**CITY OF CHARLOTTESVILLE
BOARD OF ARCHITECTURAL REVIEW
STAFF REPORT
July 17, 2018**

BAR 17-03-03

612 Grove Avenue

Screened porch

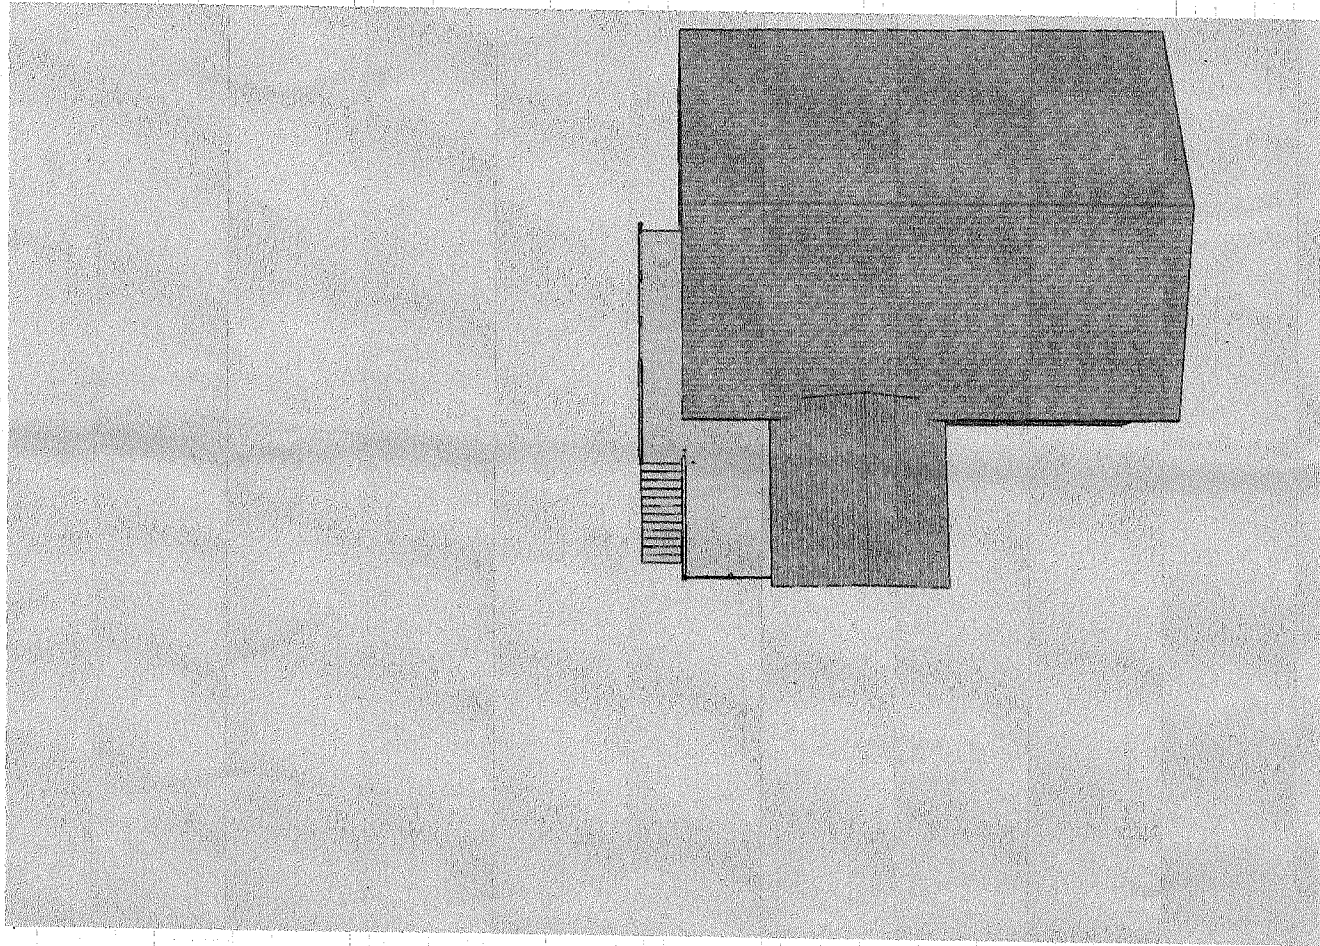
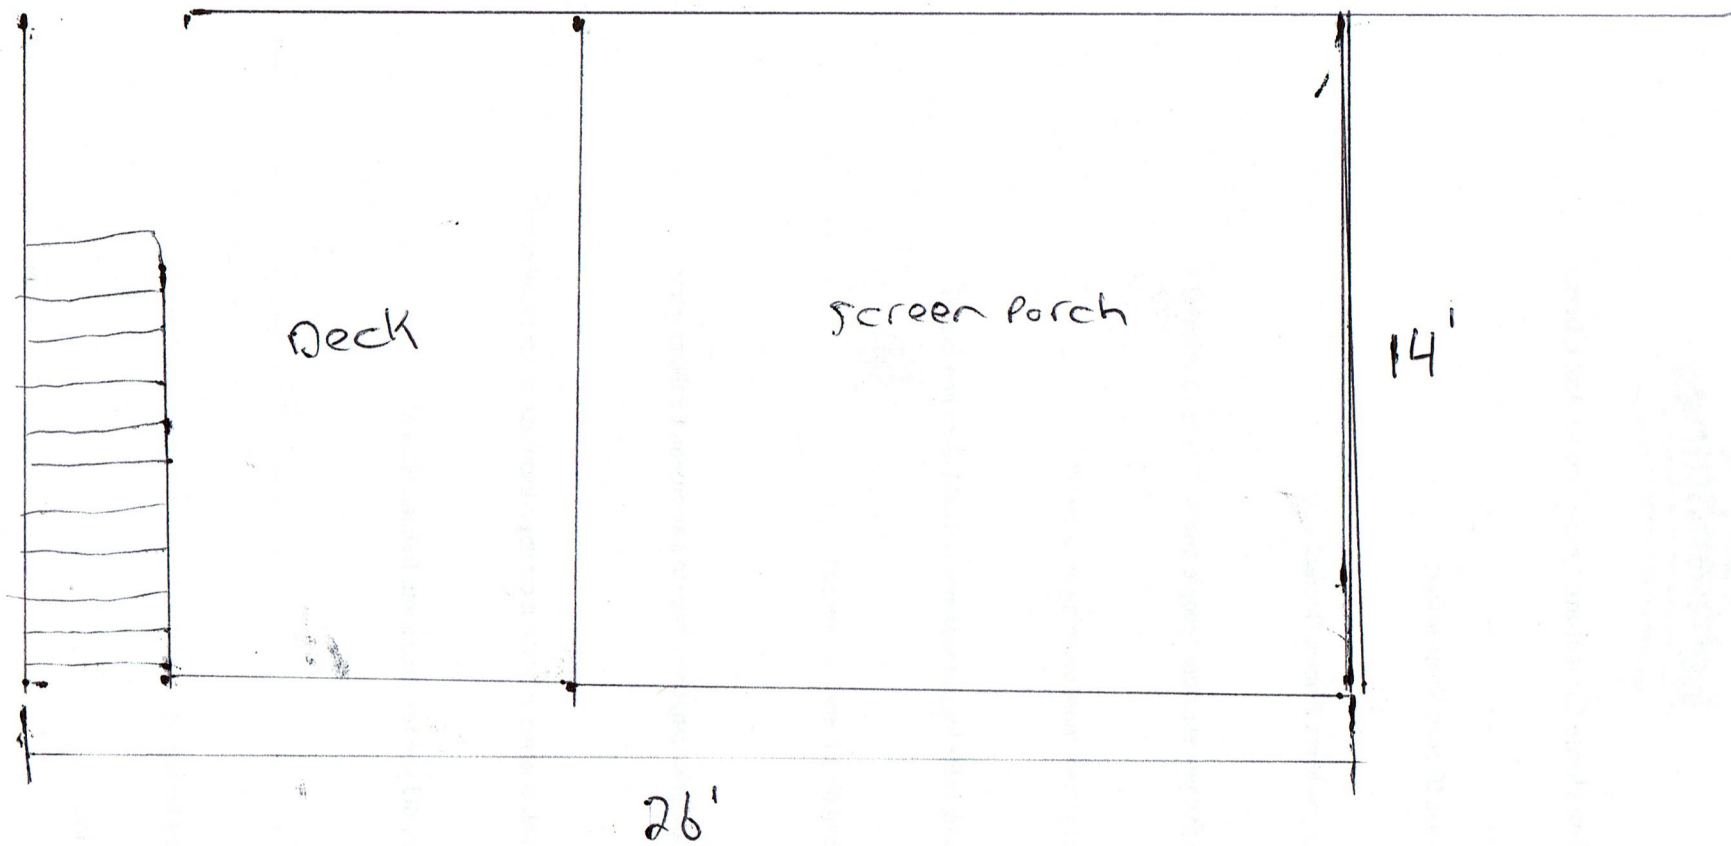
However, some items remain unaddressed. Staff has requested that the applicant make available the following:

- ~~Railing design and material.~~
- ~~Deck stain color (or paint), if any.~~
- ~~Height of the shorter section of privacy screen.~~
- ~~Clarify condition at the west end of the 3'-0" deck extension.~~

- 1x6 horizontal railing, (no pickets)
- The deck, stairs, rail, screens will be stained medium brown/walnut. Min-Wax *Early American*.
- The screened porch trim, door will be painted white to match the trim on the house.
- The low privacy screens [on side] are not screens, but rails at standard height, with horizontal railing like rest of deck and screened porch.
- Side deck will align with existing concrete deck.

Plan View

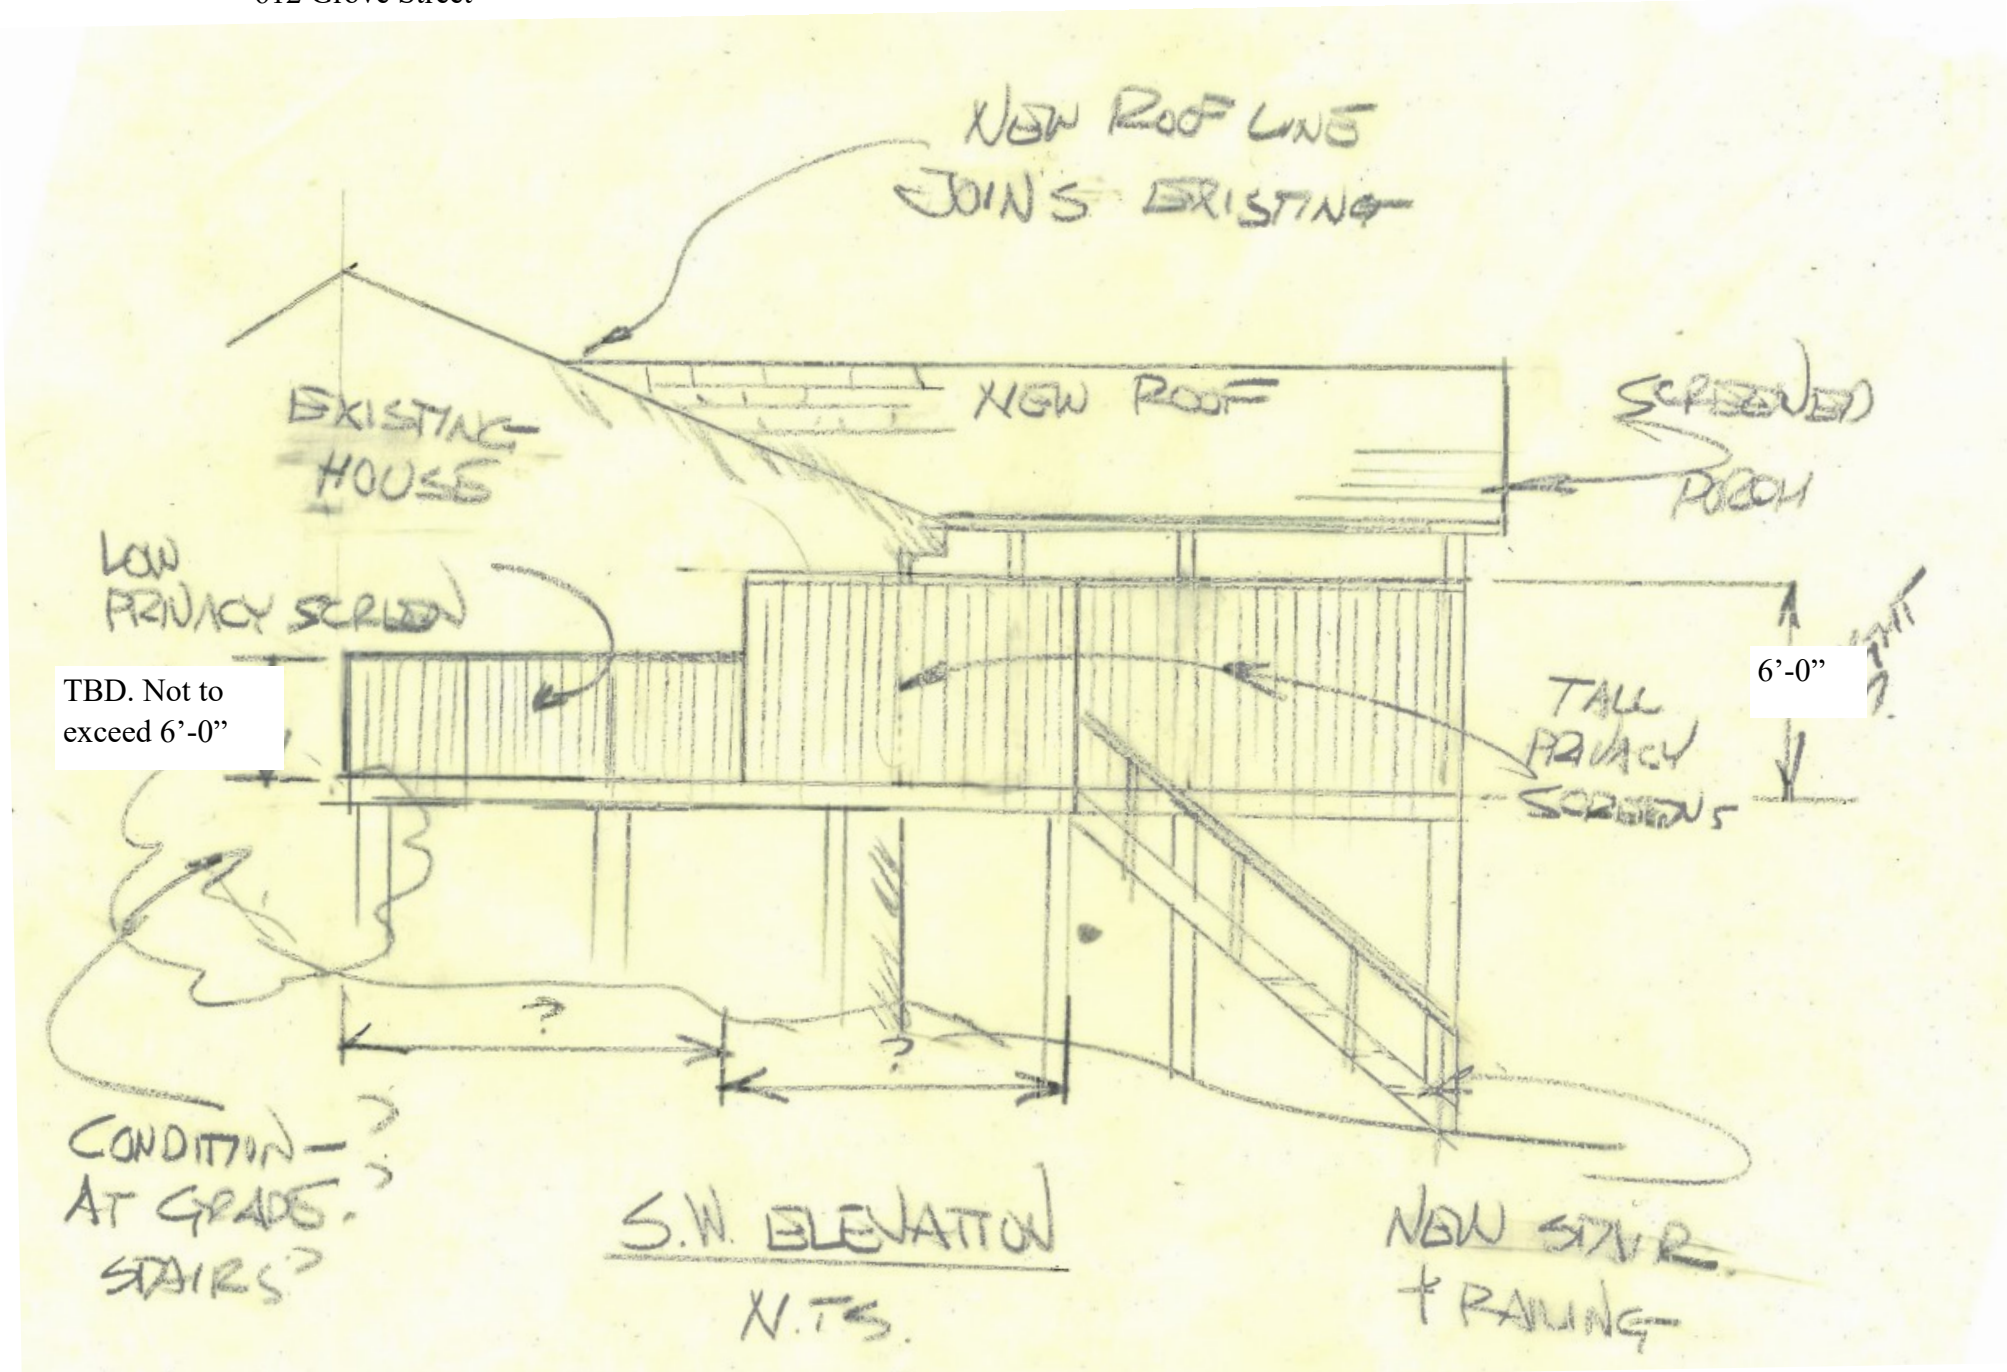
The overall design and placement of the proposed porch has been improved since the previous submission. The roof line of the screened porch is lower than the roof line of the existing building, so it does not overpower the original structure. It would be preferable for the porch eave to align with the existing. The simple form of the porch is compatible with the porches on surrounding buildings.

Ridgeline connects with existing roof, valleys on either side.
Roof shingle (color): Match existing

Single ridge pole over header..
(Per Sketch up rendering)

Privacy screen: 1 x 6 plank fencing, PTP, 6-foot height.

Horizontal 2x4s with pickets. PTP

Stair: PTP treads on stringers, 1 x 6 riser per code.
